Subject: Reply to a Notice of Nonconformance, Request for additional information

Docket No: 99901461
Reference NRC Inspection Report No. 99901461/2015-201
Nonconformance 99901461/2015-201-03

NRC request for additional information:

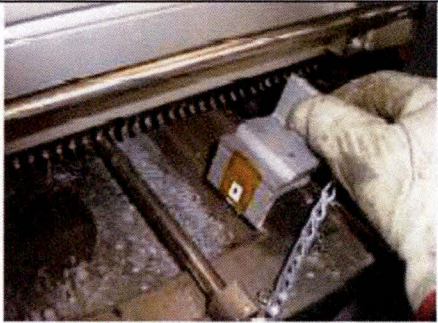
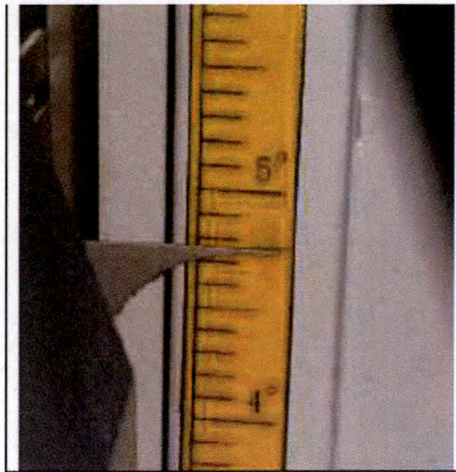
Please describe how Canberra has evaluated any additional critical parameters effecting WSM performance. Additionally, please describe the extent-of-condition review to determine the potential adverse impact of using alternatives to manufacturer recommendations on other solder machines or during other solder procedures effecting safety-related components. The inspectors are specifically interested in control of any induced latent failure modes that could affect seismic and other qualifications not detected by the Canberra post soldering inspection process.

With a gloved hand install the solder level fixture as shown on either front side of the solder pot.

Verify the solder level at a minimum is at the bottom of the solder level fixture. If not, add solder to the pot accordingly.

With a gloved hand remove the solder level fixture from the solder pot.

These steps as defined by Canberra work instruction "Wave Solder Operating Instructions & Daily Maintenance" maintain proper wave pot solder levels to ensure proper operation.
